marantz			Date: 18-Mar-2005 Model: CD5400		
			1 / 2	REF.NBR: MZ05-010	
SERVICE BULLETIN		Subject	Subject:		
Level	Application:	CD DW Disc counct be alread			
**	See below	CD-RW Disc cannot be played.			
		Int.ref:

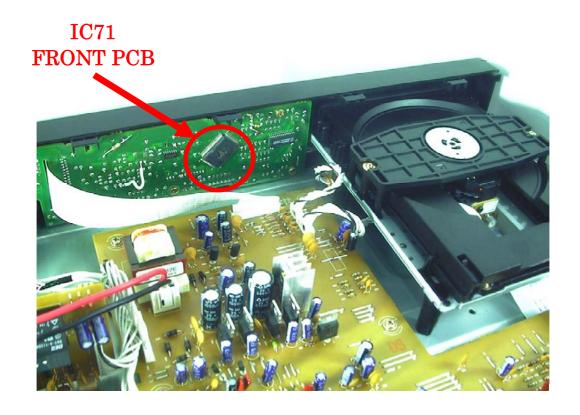
TOC of CD-RW Disc is not read.

Replace correct MICROPROCESSOR (O.T.P programmed) IC71 on the FRONT PCB.

First of all, please check the Micro processor version. It can be confirmed on the "SERVICE MODE", please refer to the CD5400 Service Manual on page 4 for the procedure.

OLD NEW	POS.NO.	PART NO. (FOR EUR)	PART NO. (MJI)	PART NAME	DESCRIPTION	FACTORY CODE NO
OLD	IC71	*HU100730R	*HU100730R	I.C O.T.P.	TMP87PS71AF(O.T.P) Ver. 2003-11-26-1	
NEW	IC71	90M-HU100760R	90M-HU100760R	I.C O.T.P.	TMP87PS71AF(O.T.P) Ver. 01-19-1	HVITMP87PS71AF

New version 01-19-1
